TECHNICAL NOTE

Job Name: Kings Meadow View, Reading

Note No: TN003

Subject: **Transport Response to Consultee Responses by Reading Borough Council**
Transport Development Control and Active Travel England

Figure 2-1: Active Travel Distribution Routes

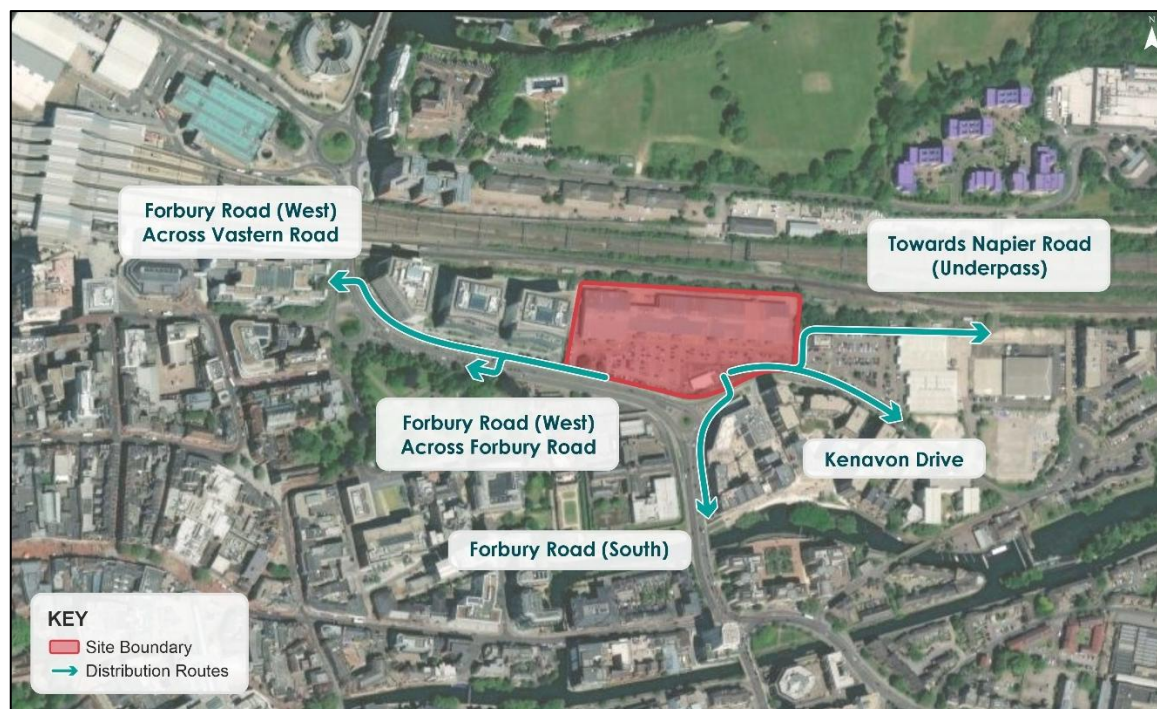
“ATE is pleased with aspects of the trip generation, especially the assumed distribution of walking and cycling trips. However, ATE requests this to be broken down to provide an hourly distribution for both walking and cycling instead of just relying on peak time figures. This is particularly important to ensure school journeys are accounted for correctly.”

Tables 2-1 and 2-2 below provide hourly distributions for walking and cycling trips under the proposed scheme, which are in accordance with the distribution percentages shown in TA Table 8.3, and the routes are shown in **Figure 2-1**. This shows a demand for active travel across the day, including the early afternoon school period.

Figure 3-1: Site to Local Amenities Desire Lines

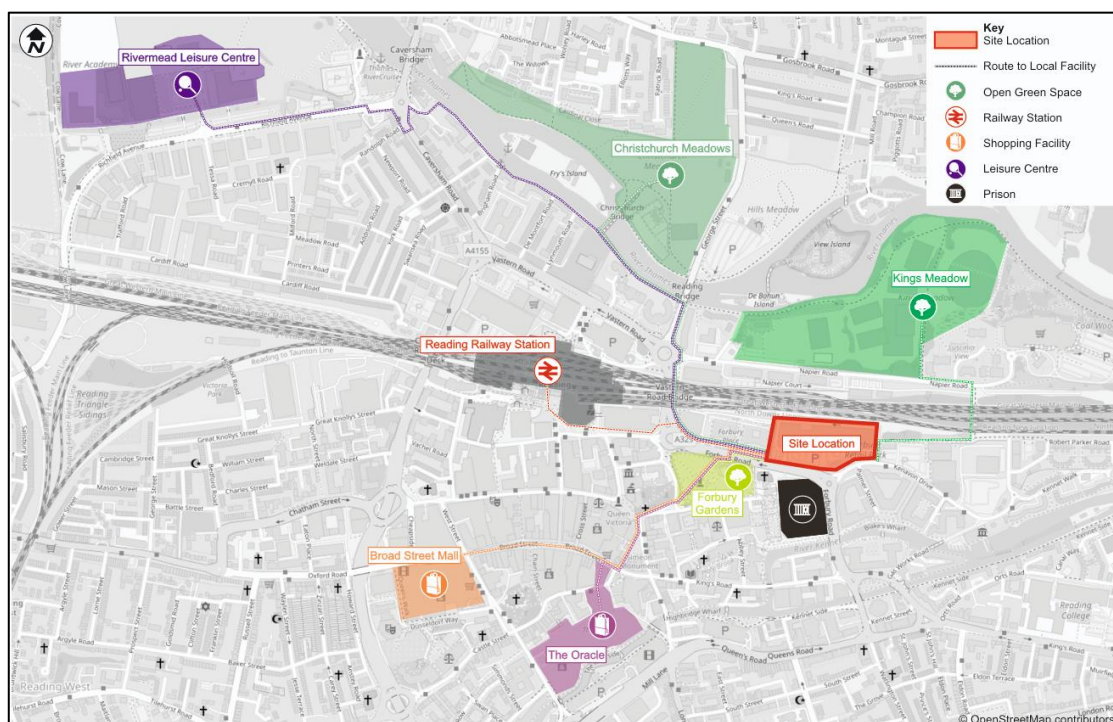
It is the Highway Authority's view that improvements should be made to the western arm of the Forbury Road/Kenavon Drive roundabout to improve crossing facilities on the desire line for those accessing bus stops on Kings Road or other key destinations to the east of the town centre. This is supported by the response from Active Travel England states "ATE requests improvements to the western leg of the Forbury Road/Kenavon Drive roundabout to improve walking routes to the bus stop on Forbury Road. It is noted that this crossing is uncontrolled, has multiple wide lanes and lacks tactile paving. This position is supported by the LHA. A controlled crossing here would be preferable to cater for the desire line towards the bus stops and access to Kings Road".

Given that any required pedestrian crossings would need to be secured through a S106 Agreement, the feasibility of delivering a formal crossing in this location must be fully assessed as part of the application, and where appropriate, its provision should be secured through the planning process."

The site location is such that the clear desire lines from the site are west to the existing crossings on Forbury Road or east and south to the canal area or underpass crossing north under the railway, see **Figure 3-1**.

To the west of the roundabout is not considered to be a strong desire line, as it leads to the former prison and prison walls. The bus stop referred to has services that terminate in the town centre (see details below). It is unlikely many people would walk to that bus stop to catch a bus when the centre of the town is within a short walking distance, as that would not be attractive.

There is an existing crossing c.190m to the west of the informal crossing. This is provided on the desire line to access the town centre via Forbury Gardens Park.

FORBURY DEVELOPMENT
KINGS MEADOW VIEW - INDICATIVE
CYCLE ROUTE

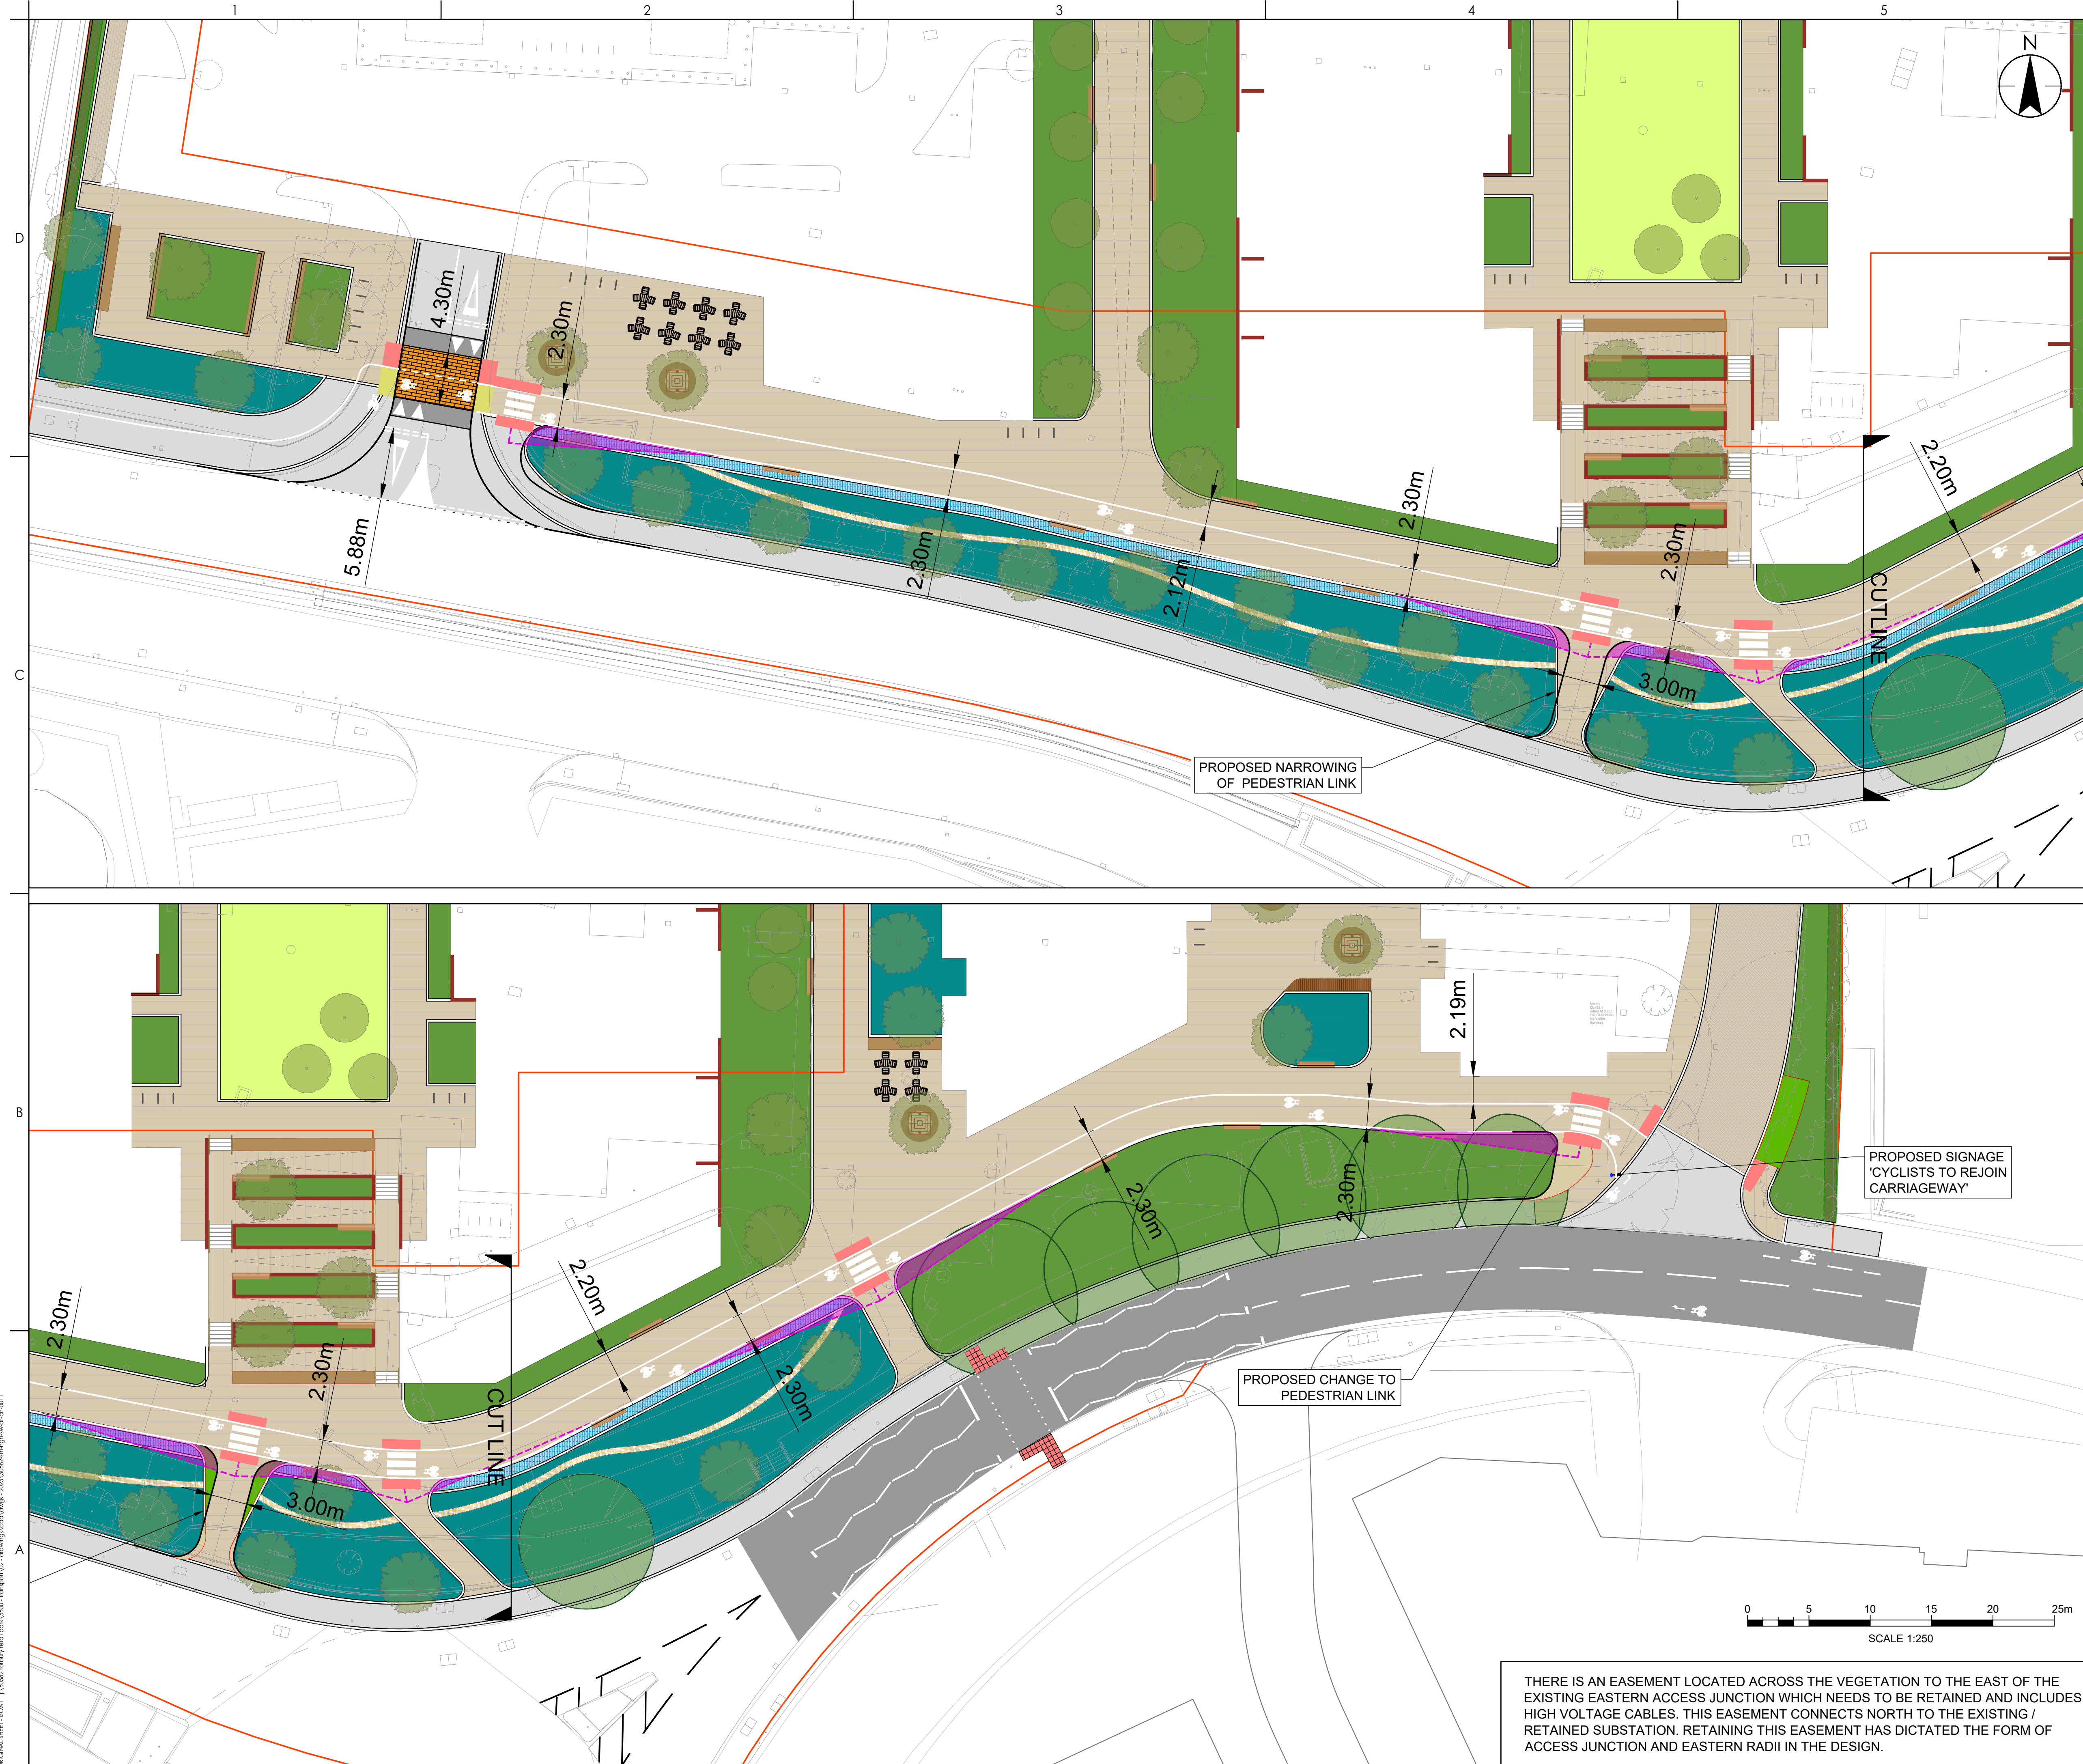
"The application includes a cycle route that runs along the site's internal southern edge. The cycle path will route between the east and west site accesses, with improvements to the western access point to allow pedestrians and cyclists to access the site. It is stated that one TPO tree will have to be removed to facilitate the indicative cycle route and changes to the eastern access junction. Drawing 50582-STN-HGN-SW-DR-CH-0011-P02 in Appendix C of the Transport Assessment illustrates how the indicative cycle route could be delivered in accordance with the Parameter Plans.

However, LTN 1/20 establishes that a two-way cycle track should generally be at least 3.0 m wide. This width must be increased where flows are high or where there are vertical obstructions (such as walls, fences, railings, tree lines, or other fixed features), as additional space is required to maintain safe passing distances and avoid conflict. Therefore, the proposed design does not comply with these requirements."

"Within the site, ATE requests cycle and pedestrian provision to be separated to reduce the risk of conflict, and ensure the route is LTN 1/20 compliant to allow people to use it as an onward connection."

The **Appendix A** design is indicative. It is 2.3m in width, which meets and exceeds the minimum width of 2.0m in LTN1/20. It also does not route the cycle route against vertical obstructions. The flows for cycling are not high from the development (as it is easier and quicker to walk shorter distances, such as to the station). The indicative design meets the standards.

The active travel provision is separated, comprising a cycleway 2.3m wide and a footway 2.2m wide, with a combined width of 4.5m for the active travel corridor. This is shown in the indicative drawings in **Appendix A**.

The indicative cycle route is compliant with LTN 1/20. It is a constrained route and exceeds the absolute minimum of 2.0m at constraints as set out in LTN 1/20 Table 5.2. The cycle route design is indicative and will be reviewed and updated once the detailed layout is available as part of the reserved matters application. If further width is possible, this will be provided.
